SUBJECT: Submission of Additional U.S. Department of Energy Responses to Requests for Additional Information for the Phase 1 Decommissioning Plan for the West Valley Demonstration Project from U.S. Nuclear Regulatory Commission Review

RESPONSES TO THE
U.S. NUCLEAR REGULATORY COMMISSION
REQUEST FOR ADDITIONAL INFORMATION
ON THE WEST VALLEY DEMONSTRATION PROJECT
PHASE 1 DECOMMISSIONING PLAN

GROUP 2 RESPONSES

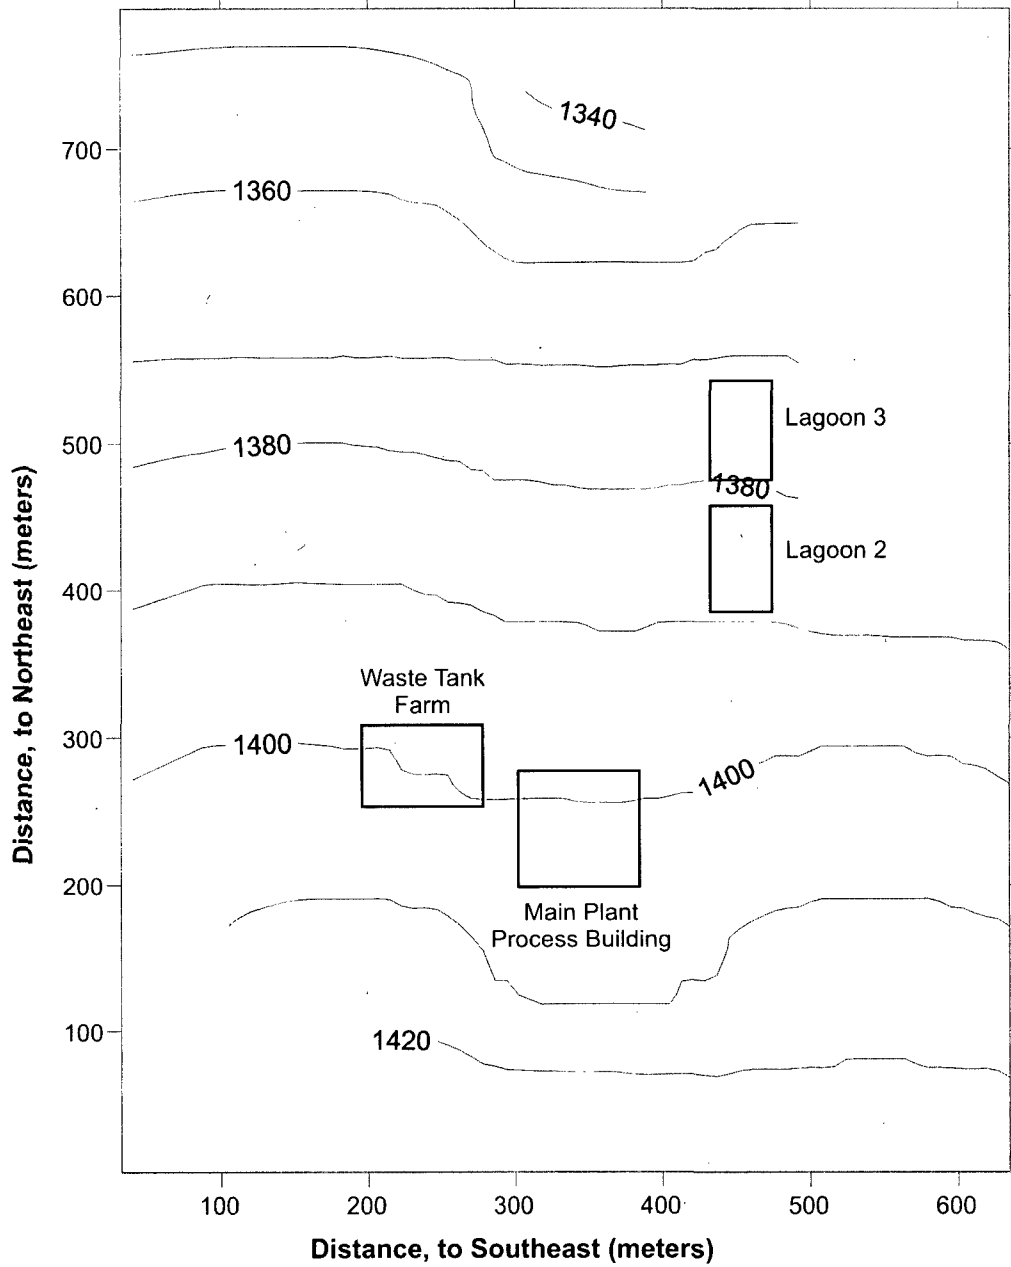
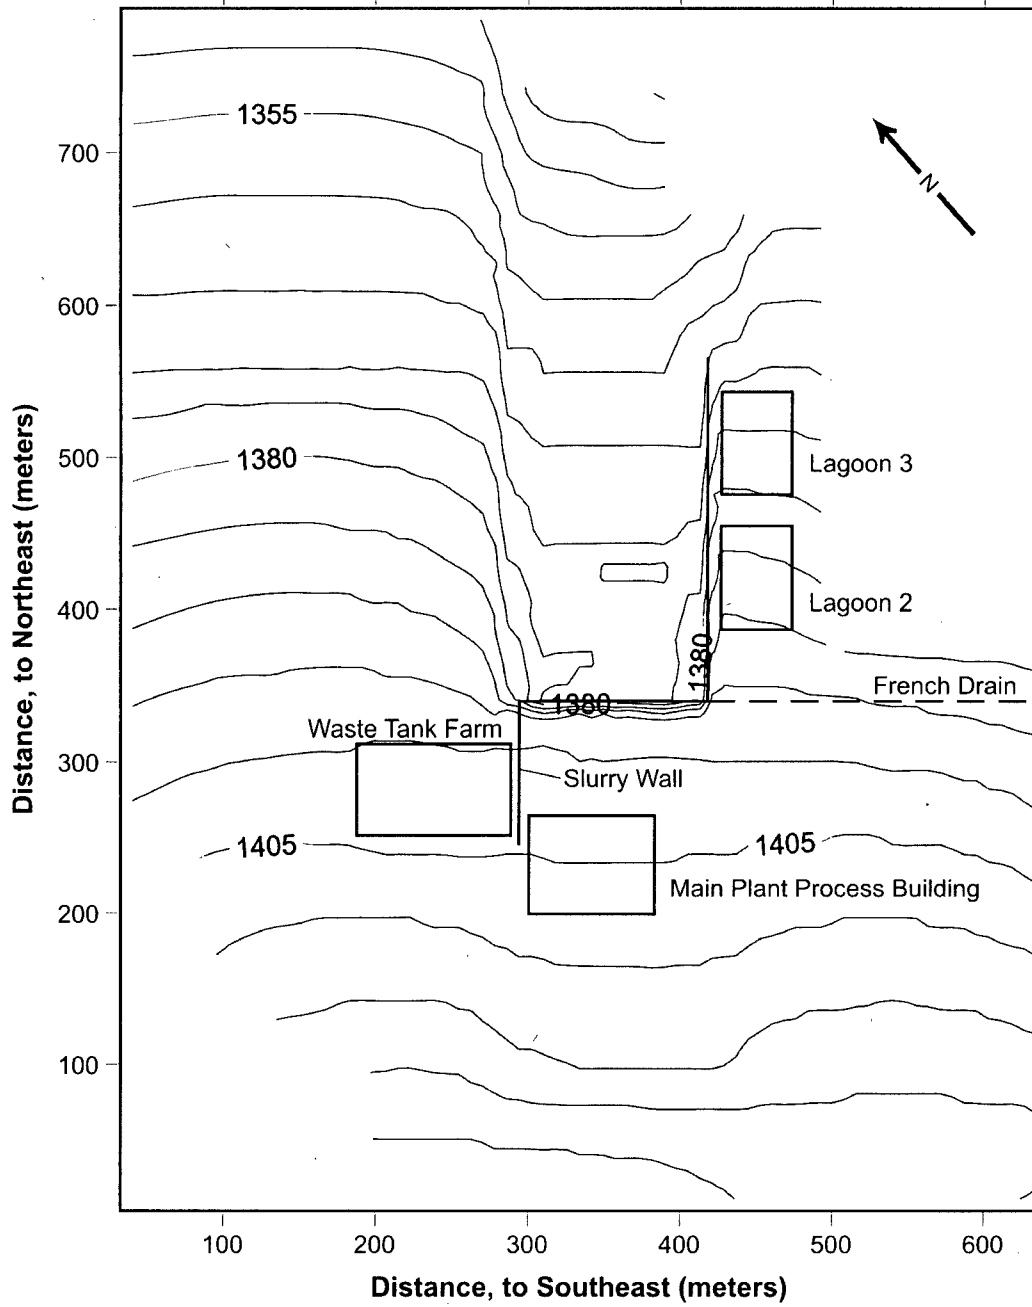
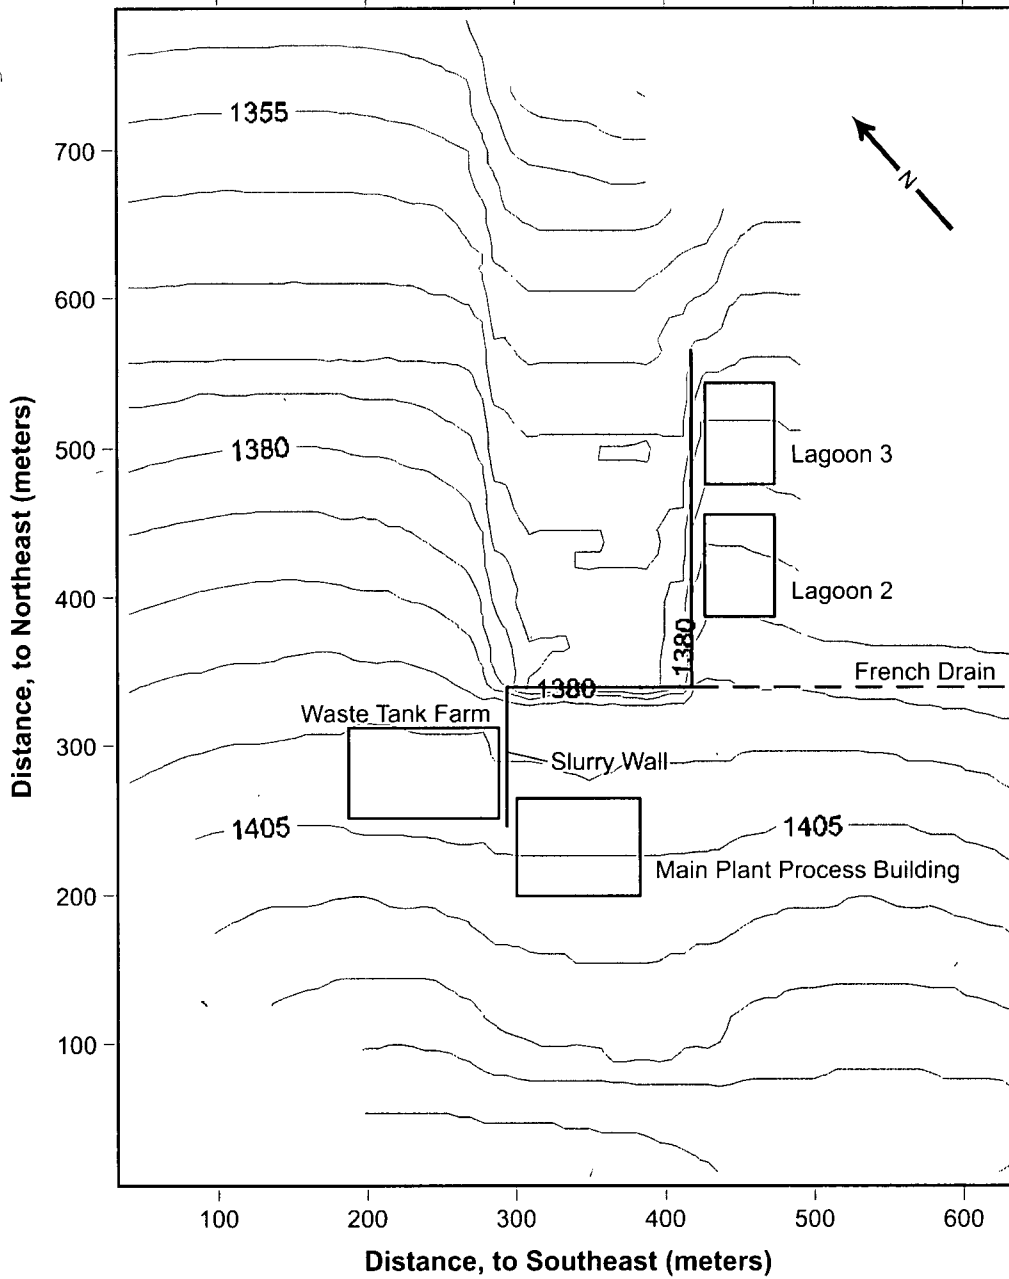
The role of the hydraulic barriers in alteration of the configuration of the water table is illustrated in Figures 5C3-1, 5C3-2, and 5C3-3 for the three cases. At this level of detail, the difference between the case of no barriers (Figure 5C3-1) and presence of barriers (Figures 5C3-2 and 5C3-3) is clear, but little difference can be found for comparison of design and degraded French drain.

Figure 5C3-4. Influence of Presence of Engineered Barriers on Elevation of the Water Table along a Southwest-to-Northeast Transect Through the Process Building Excavation. (Note that there is an elevation drop of more than 20 feet across the hydraulic barrier.)

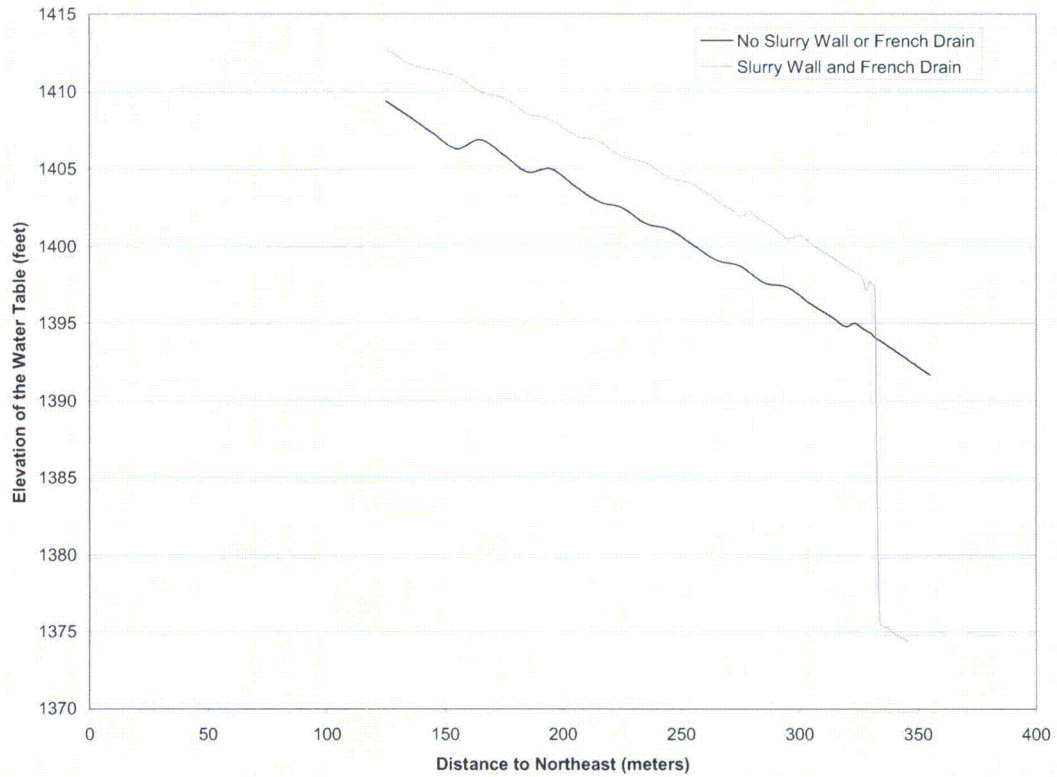
A greater level of detail is discernable for the plot of the water table along a southwest-to-northeast line passing through the center of the Process Building excavation. The result is presented in Figure 5C3-4 for comparison of the background and engineered barriers cases. This

Figure 5C3-5 Influence of a Well on Elevation of the Water Table Along a Southwest-to-Northeast Transect Through the Process Building Excavation

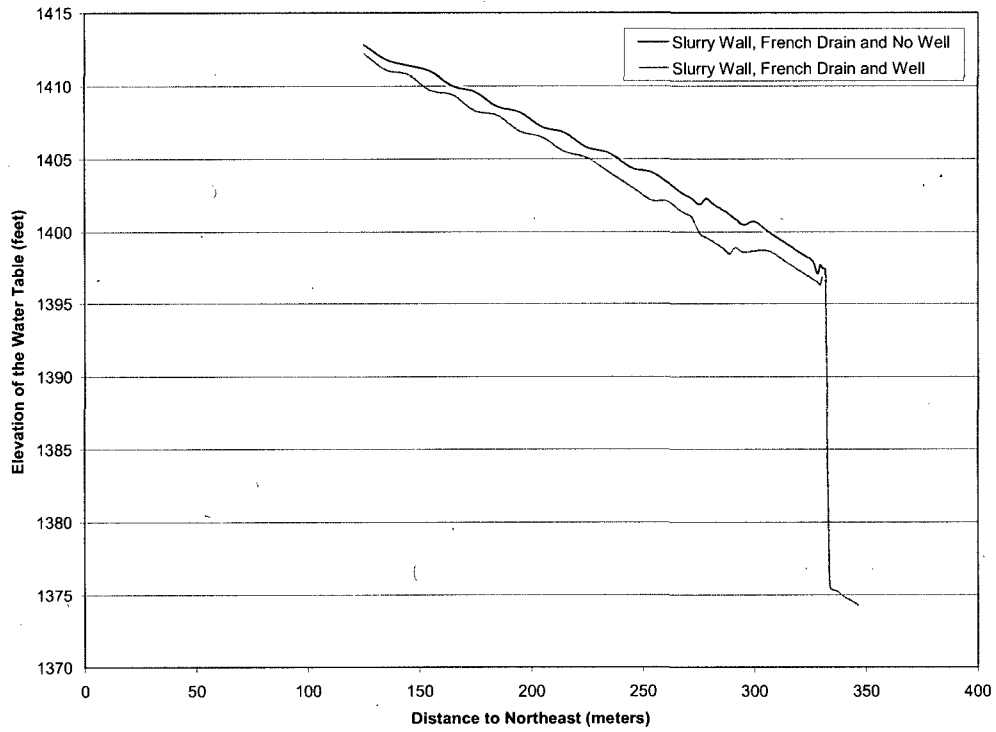
As discussed in a preceding comment, it is recommended that DOE provide results of calculations or perform additional modeling (e.g., multi-dimensional groundwater modeling using STOMP) to show the impacts of (i) a pumping well, and (ii) hydraulic barriers on the flow field in the immediate vicinity of WMA 1 and 2 excavations and potential transport of contaminants from the Lavery Till to a the drinking water well located in the sand and gravel. DOE should also evaluate the potential risk associated with transport of contamination from the Lavery Till to the KRS or to surface water. This information could be used to provide additional support that the potential contributions from subsurface contamination to the overall risk from the site from other pathways of exposure (i.e., drilling scenario) are insignificant.

Elevation of the water table along this transect for the case of design conditions of the barrier wall and French drain without a well and with a well pumping at 5,700 cubic meters per year is presented in Figure 5C3-5. The well was located at position of 280 meters on the horizontal axis of Figure 5C3-5. The results indicate that the presence of the well causes a minor general lowering of the water table and a local drawdown on the order of one meter within a radius of twenty-five meters.

Figure Att-2. Cumulative Probability Dose-Source Ratio, Sr-90 – Surface Soil

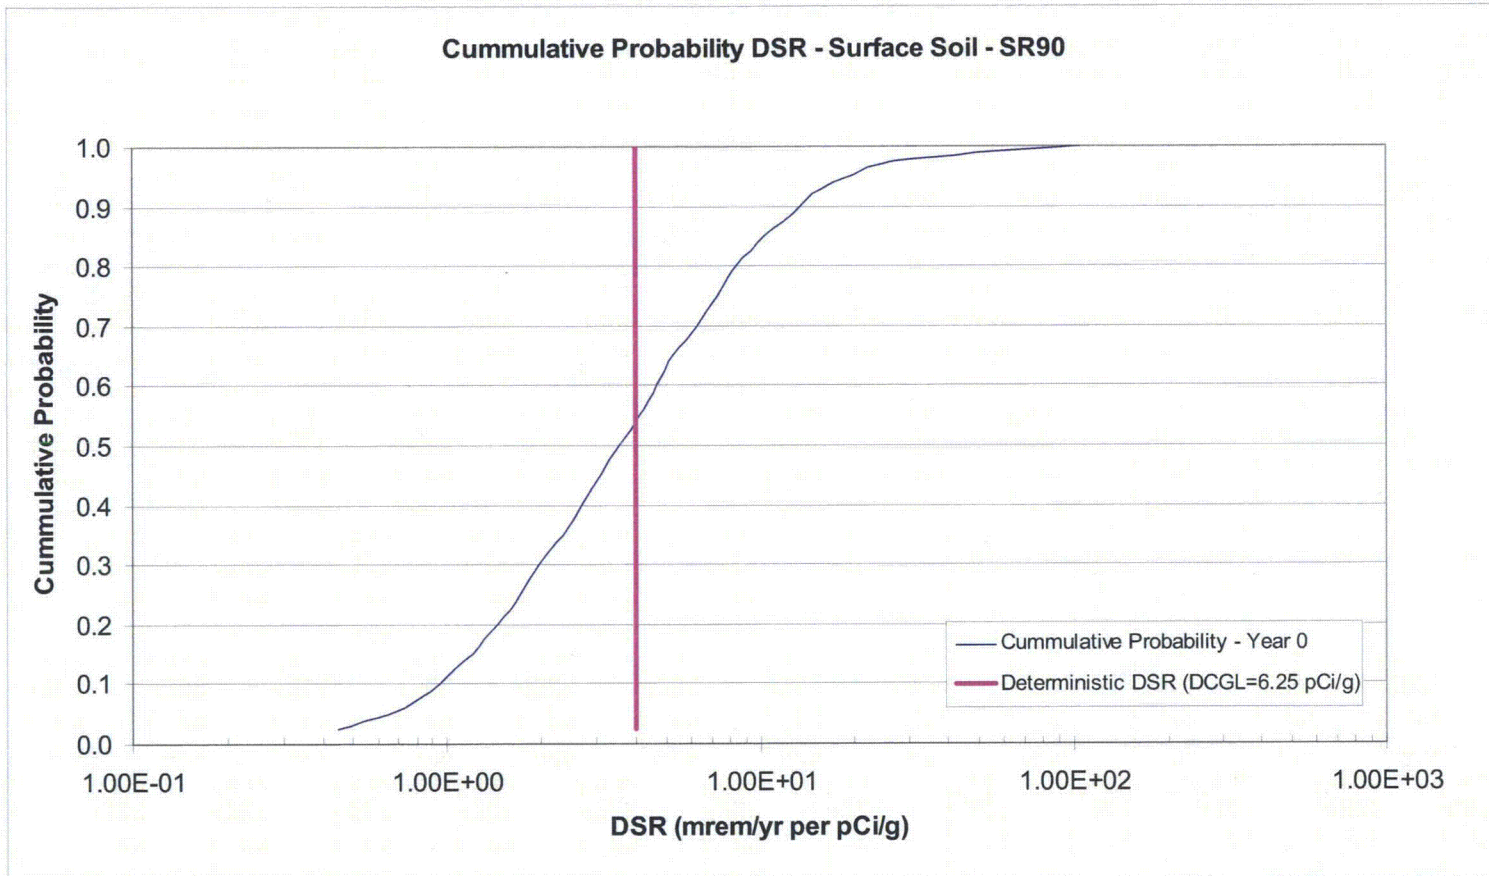
The lack of conservatism in these surface soil criteria can be quantified in another manner by considering the average soil concentrations at the deterministic DCGLs. If the average residual concentration of Sr-90, for example, were to be 6.25 pCi/g (the deterministic DCGL for surface soil), then the probabilistic modeling would indicate that the probability that the resulting dose would not exceed 25 mrem in the peak year would be approximately 55 percent (see Figure Att-2 in Attachment 1).
